V2500-A1 SERIES PROPULSION SYSTEM SERVICE BULLETIN

ENGINE FUEL AND CONTROL – FUEL METERING UNIT – INTRODUCTION OF A REVISED MAIN
METERING VALVE (MMV) END COVER

ENGINE - FUEL AND CONTROL - FUEL METERING UNIT, TYPE FMU 500
INTRODUCTION OF A METERING VALVE END COVER (77154080)
WITH AN INCREASED FLANGE FILLET RADIUS

FMU 500-73-8200

Pre and Post Modification CP8200 Metering Valve End Cover Assembly

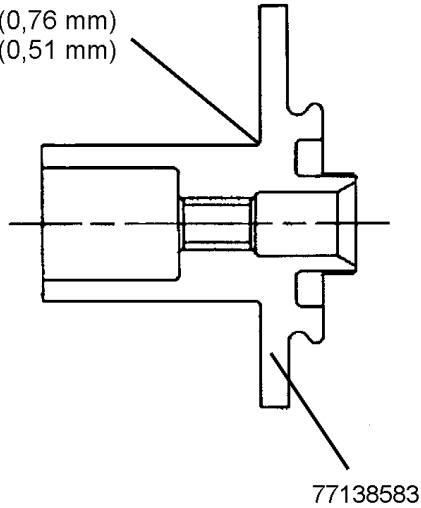
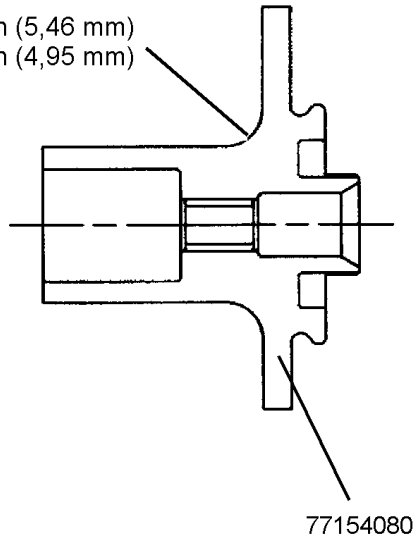
There have been four occurrences of cracks in the metering valve end cover (77138581) flange.

Stress analysis has shown that an increase in the flange fillet radius on the metering valve end cover will increase the flange strength sufficiently to prevent cracks.

The flange fillet radius on the metering valve end cover (77138581) has been increased from the limits 0.020 to 0.030 in. (0,51 to 0,76 mm) to the limits 0.195 to 0.215 in. (4,95 to 5,46 mm), Ref Fig 1.

Before Mod CP8200

After Mod CP8200

- (1) Remove the metering valve end cover assembly (77138583), Ref Component Maintenance Manual 73-22-52 DISASSEMBLY, Page Block 301.
- (2) Install the post mod CP8200 metering valve end cover assembly (77154080), Ref Component Maintenance Manual 73-22-52 ASSEMBLY, Page Block 701 and Fig 1.
- (3) Test the unit, Ref Component Maintenance Manual 73-22-52 TEST AND FAULT ISOLATION, Page Block 101.
